Subject: Class 3 Permit Modification Request, Construction and Use of Hazardous Waste Disposal Units 11 and 12 for the Waste Isolation Pilot Plant Hazardous Waste Facility Permit Number: NM4890139088-TSDF

**Class 3 Permit Modification Request**

**Construction and Use of Hazardous Waste Disposal Units 11 and 12**

**Waste Isolation Pilot Plant  
Carlsbad, New Mexico**

**Figure N-4**  
**Typical Disposal Room Sample Head Arrangement**

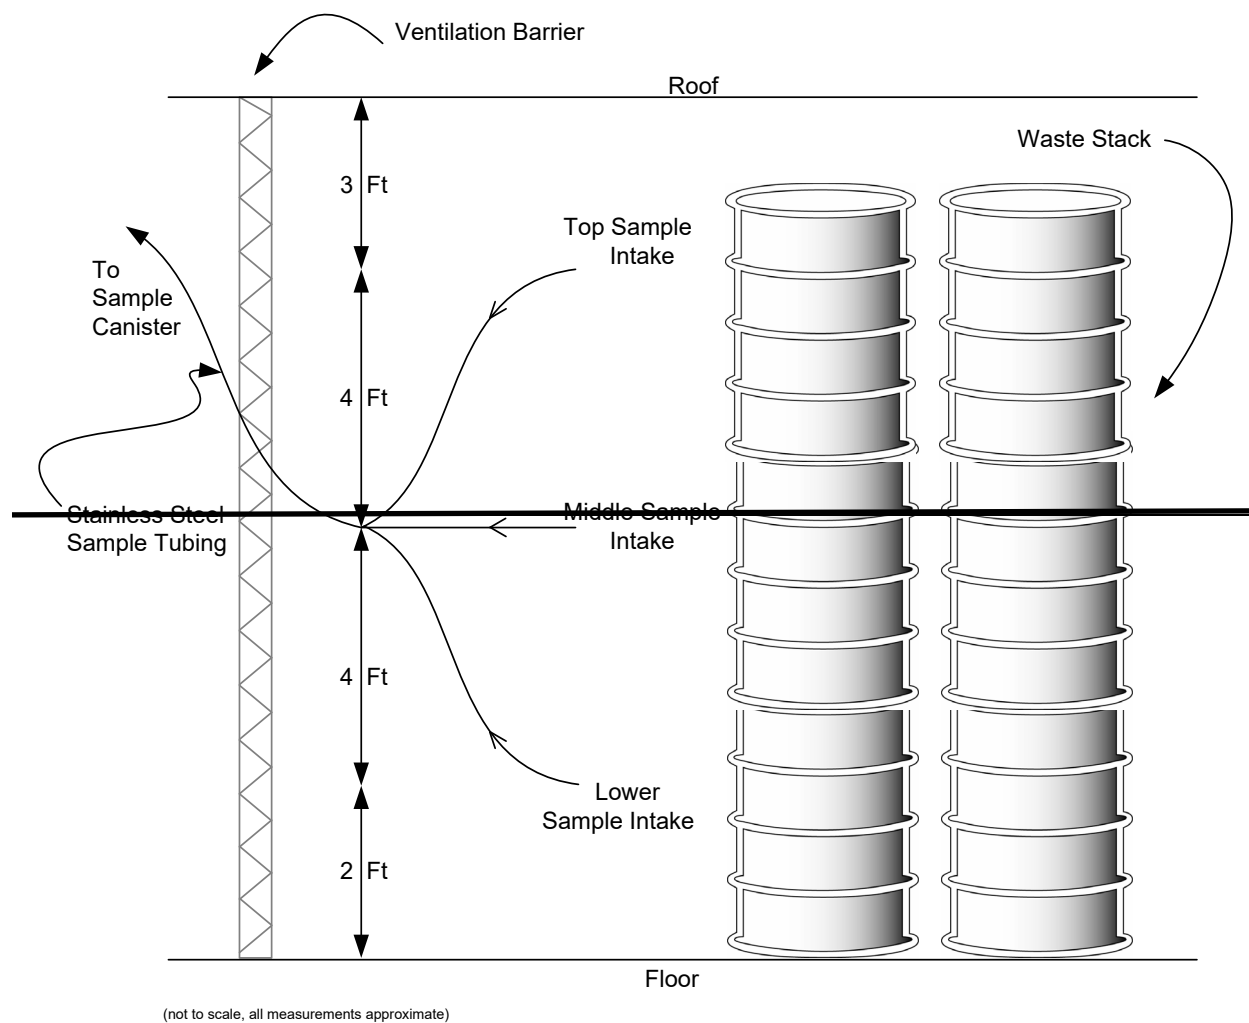
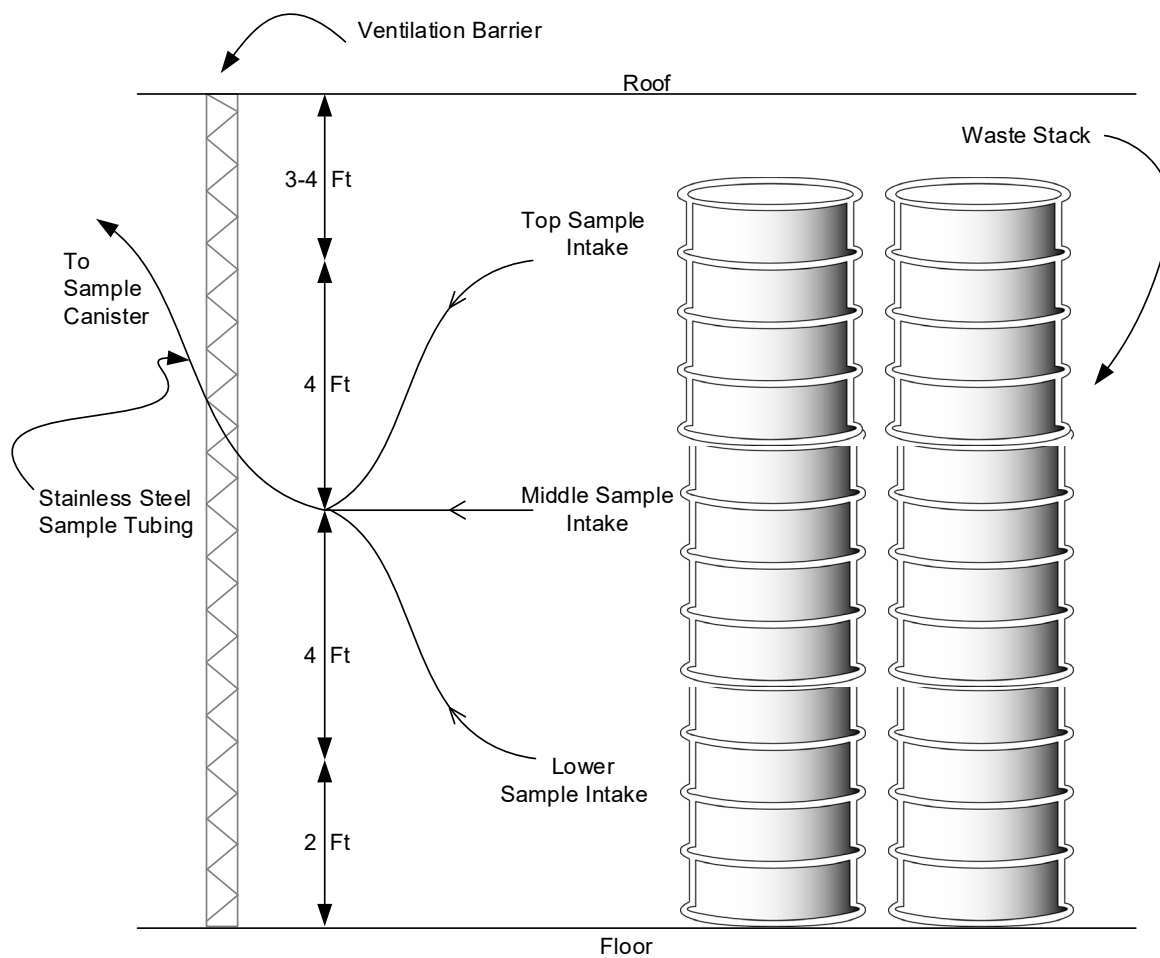
| Permit Part/Section            | Impact   |
|--------------------------------|--|
| Attachment N, Figure N-4       | Modified the upper height dimension of the room on Figure N-4. This change is needed to cover both the nominal 13 ft height at time of emplacement in Panels 1-8 as well as the anticipated nominal 14 ft height at time of emplacement in Panels 11 and 12, and to change the name of this figure to " <i>Typical Disposal Room Sample Head Arrangement</i> ".  |

| Affected Permit Section       | Explanation of Change   |
|-------------------------------|---|
| Attachment N, Figure N-4      | Replaced figure and renamed figure to “ <i>Typical Disposal Room Sample Head Arrangement</i> ”.       |
